ADDENDUM NO. 1

The following attached changes are incorporated into requirements for the Project No. 33-SBC-1001 Contract Documents by this Addendum:

KITTITAS RECLAMATION DISTRICT

SOUTH BRANCH CANAL IMPROVEMENTS

CG302
SHEET 15 OF 35

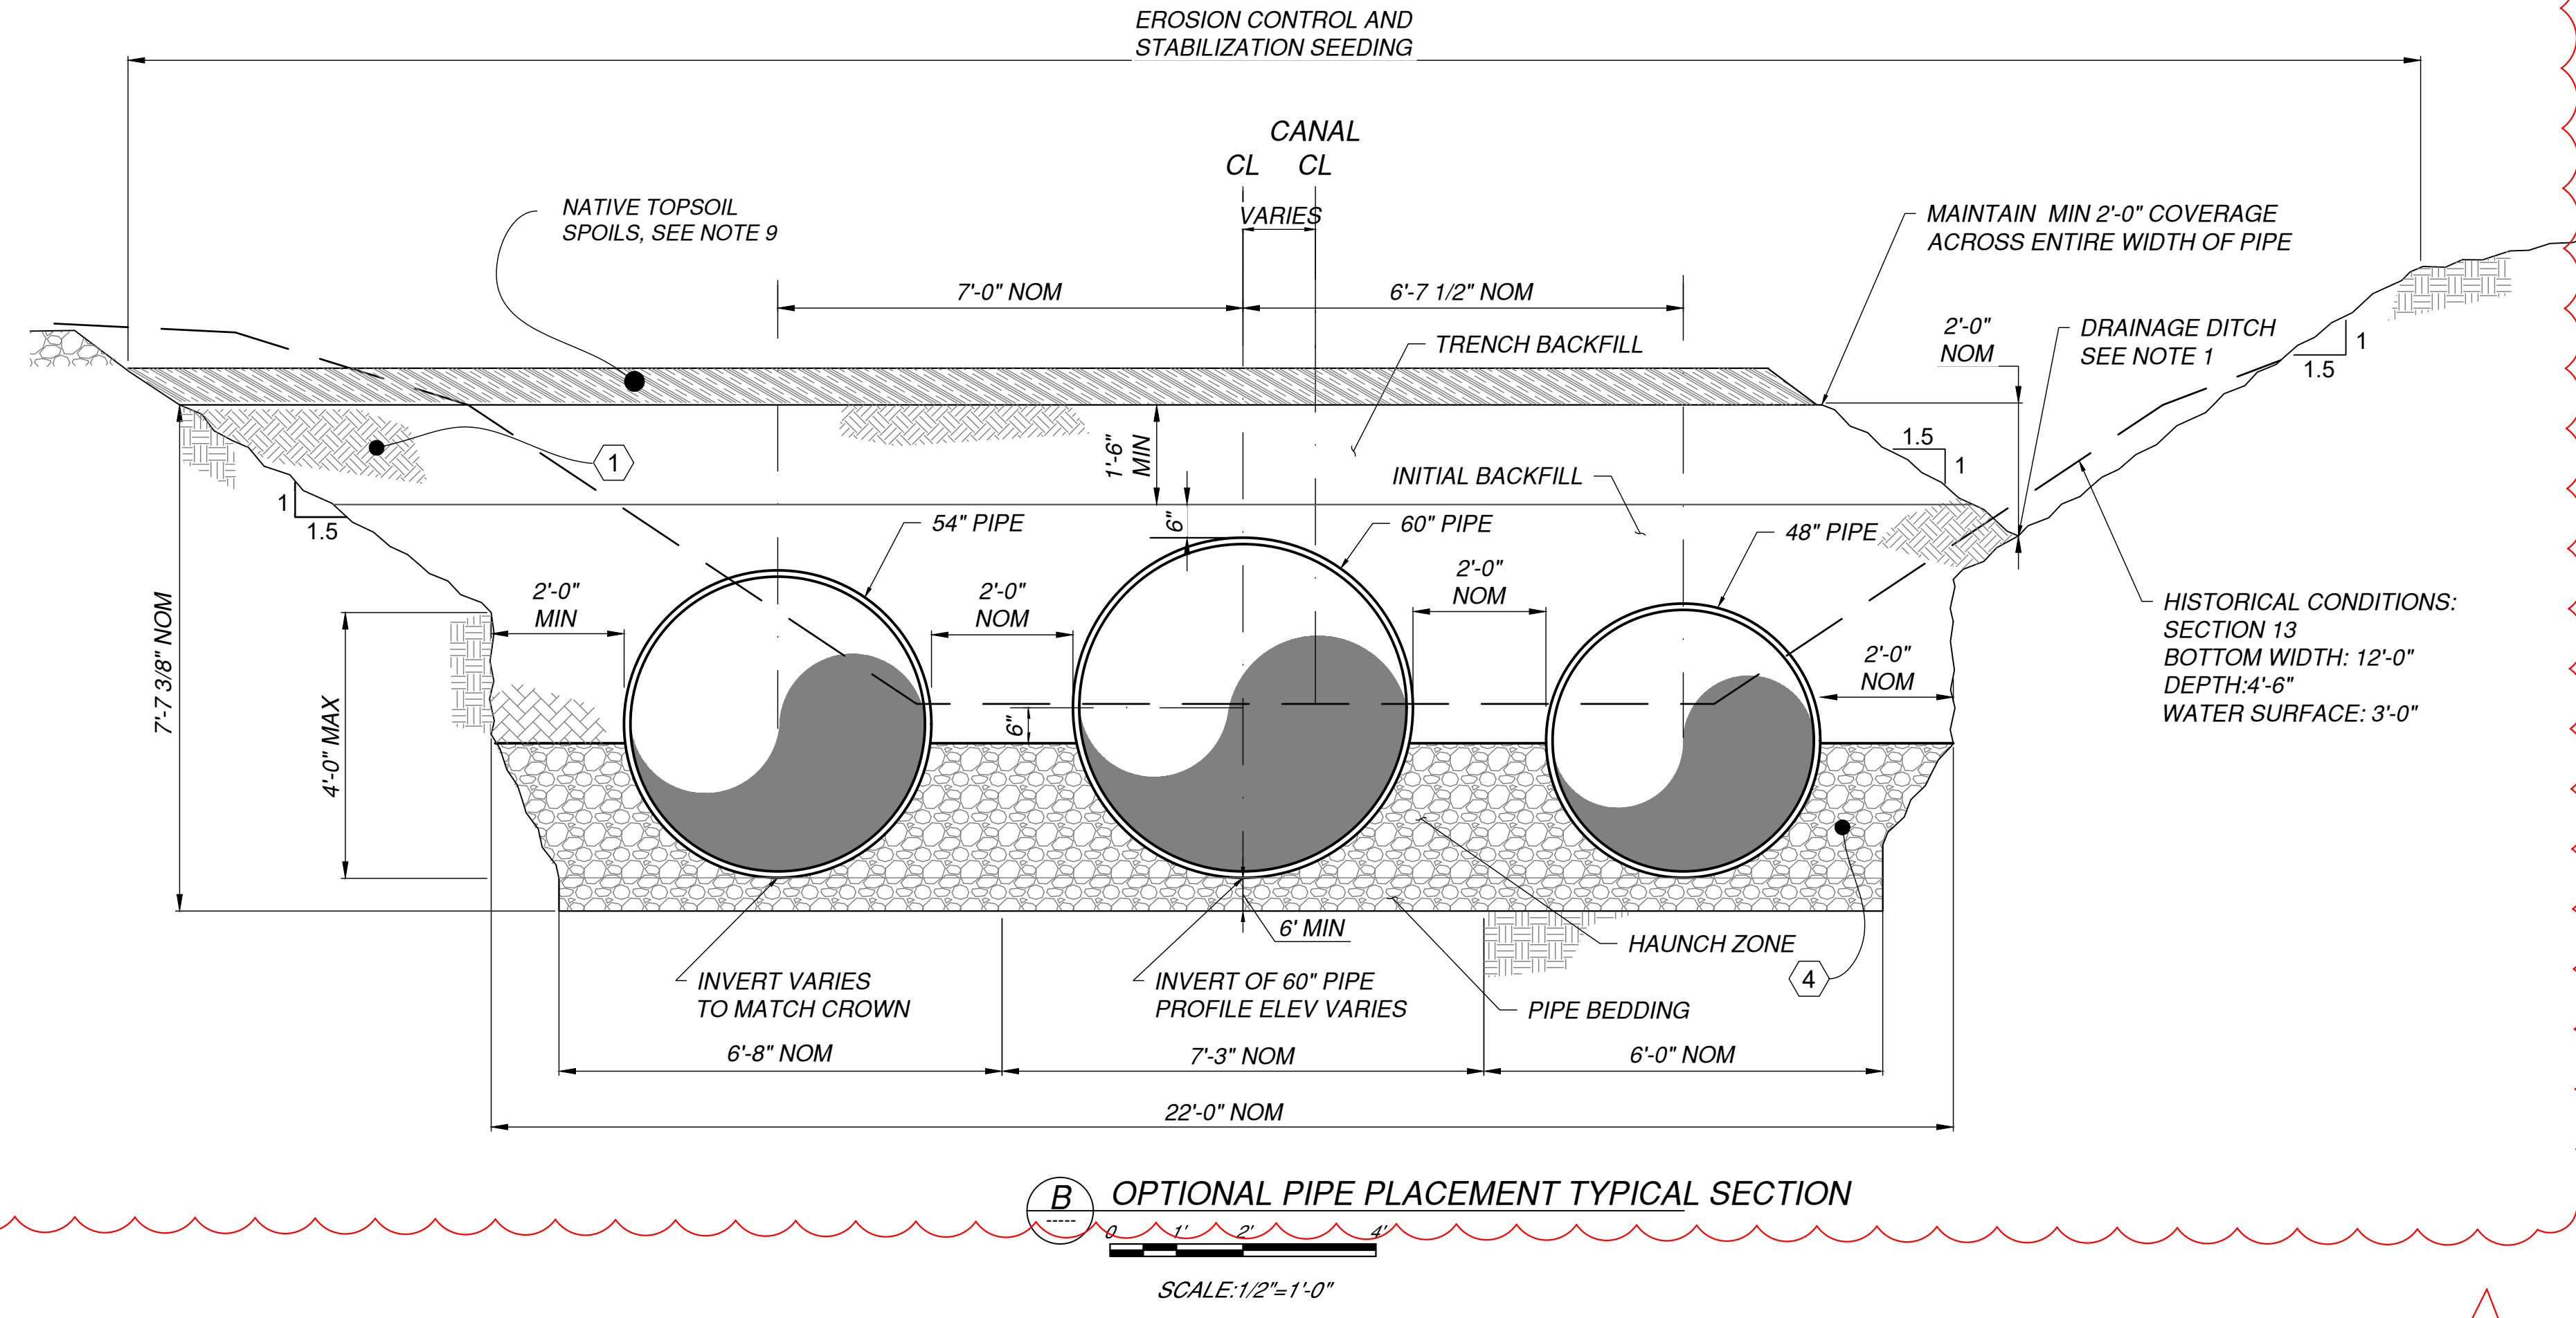
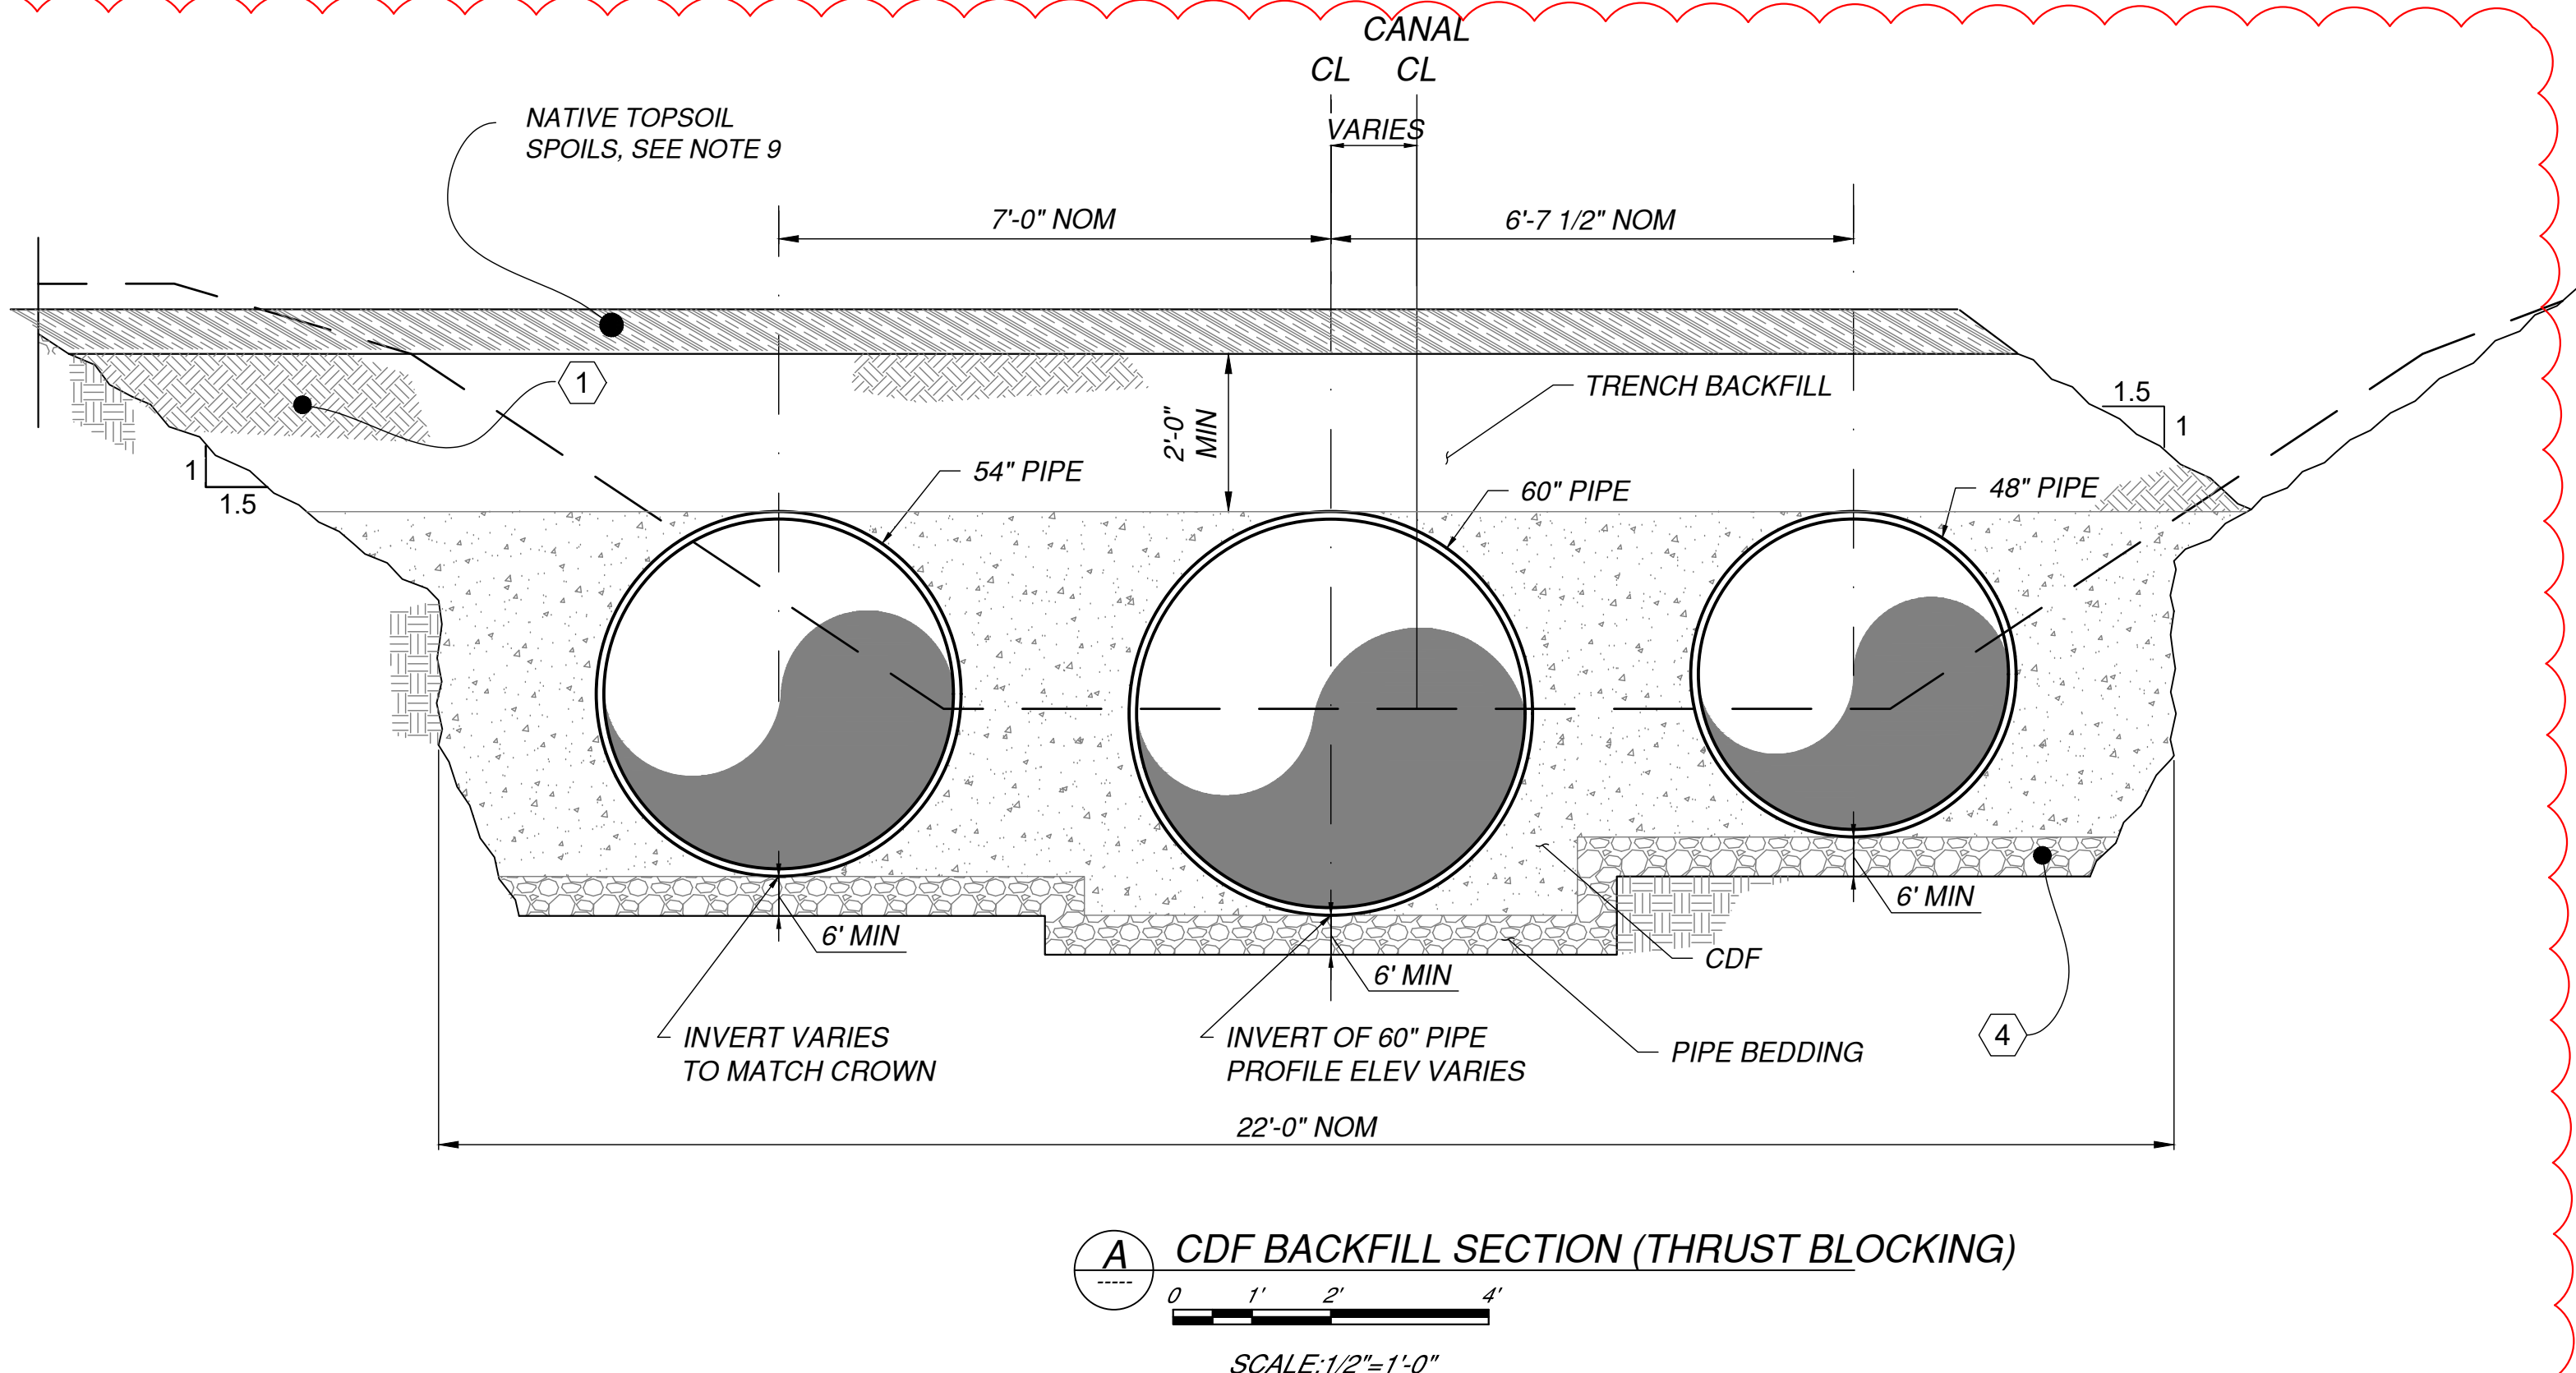
- f. Drawing CG301: Revised trench backfill material to utilize “Gravel Backfill”.
 - g. Drawing CG302: New sheet clarifying CDF backfill for thrust blocking and typical trench backfill material for alternative pipe material.

- INVERT OF ALL PIPES MEET SAME ELEVATION.
 - AT PIPE BENDS, PIPES TO BE BACKFILLED UP TO SPRINGLINE WITH CDF AS INDICATED ON DRAWING AND PROFILES. CONTRACTOR TO USE TIE DOWN ANCHORS OR OTHER MECHANISM TO GUARD AGAINST FLOTATION OF PIPE DURING INSTALLATION OF CDF.
